寄件者: Sion Weng
寄件日期: 2014年5月7日星期三 下午 5:33
收件者: Louis Cheng
副本: Jack Su
主旨: RE: manual/datasheet request

Modelo: PER-T227
P/N: 1907T22701.

Dear Louis
I have a AEC-6967 with a riser card (2 x PCI) and need the datasheet of riser card.
Modelo: PER-T227
P/N: 1907T22701.

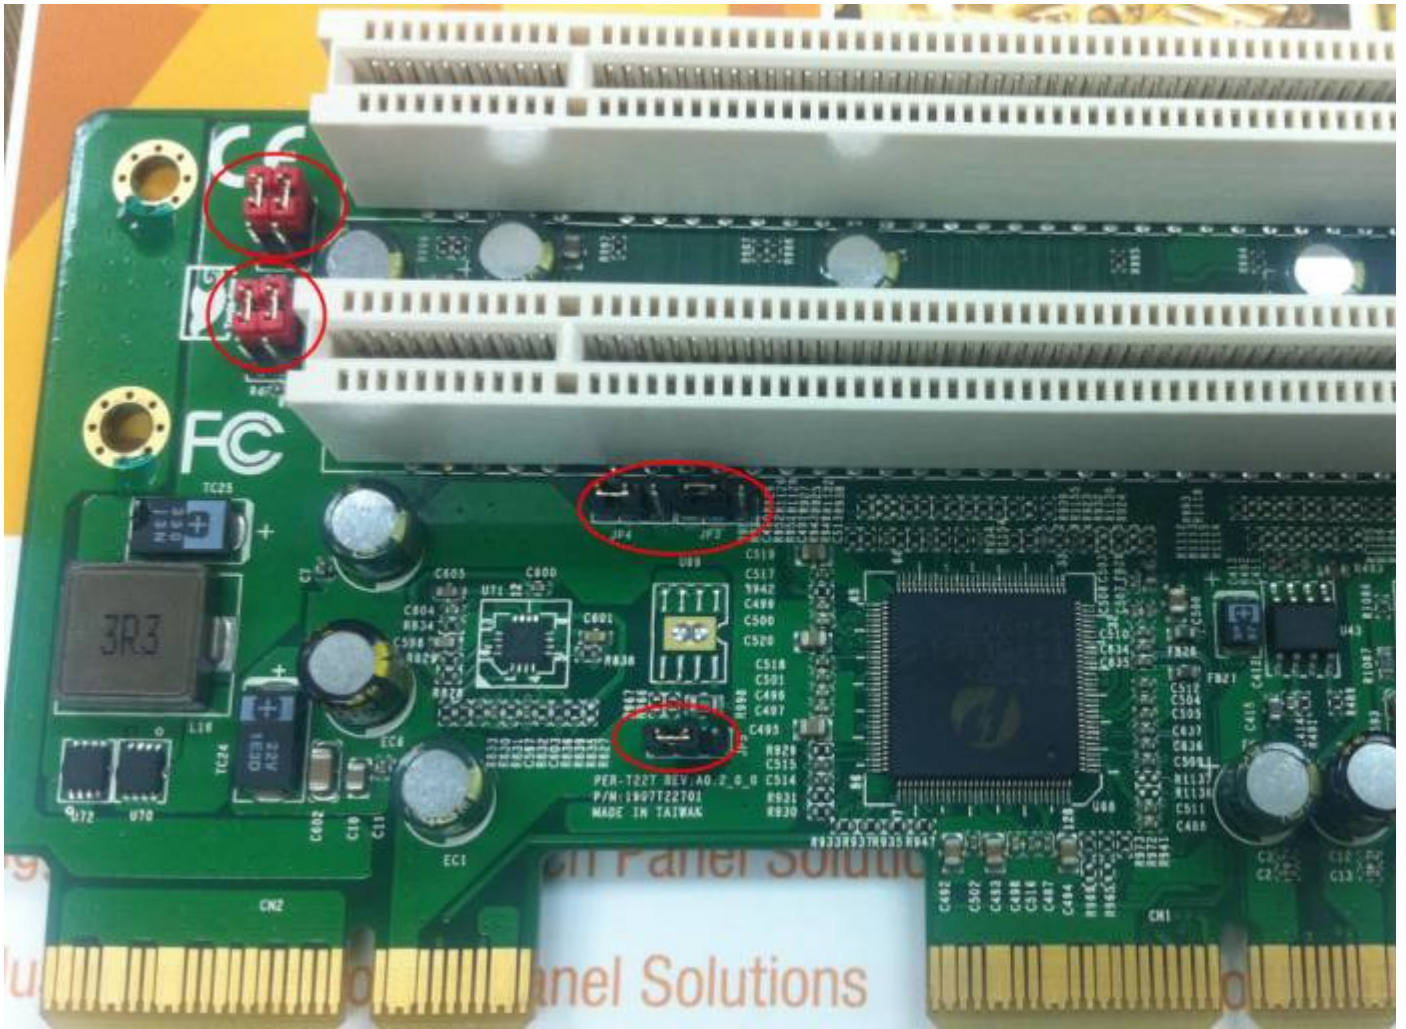
煩請您提供所有紅色 mark 的 Jumper 設定資料，謝謝您!

I need know the jumper configuration for to change 3.3/5V for PCI.
Thanks,

JP8 (PCI SLOT1)

(1-3,2-4 For 5V , 3-5, 4-6 For 3.3V)

JP3 (PCI SLOT1)

(1-2 For PCI AD17 ,2-3 For PCI AD21)

JP4 (PCI SLOT2)

(1-2 For PCI AD18 ,2-3 For PCI AD22)

JP5 (NC)

(1-2 VCC W/P enable,2-3 WP disable)

JP9 (PCI SLOT2)

(1-3,2-4 For 5V , 3-5, 4-6 For 3.3V)
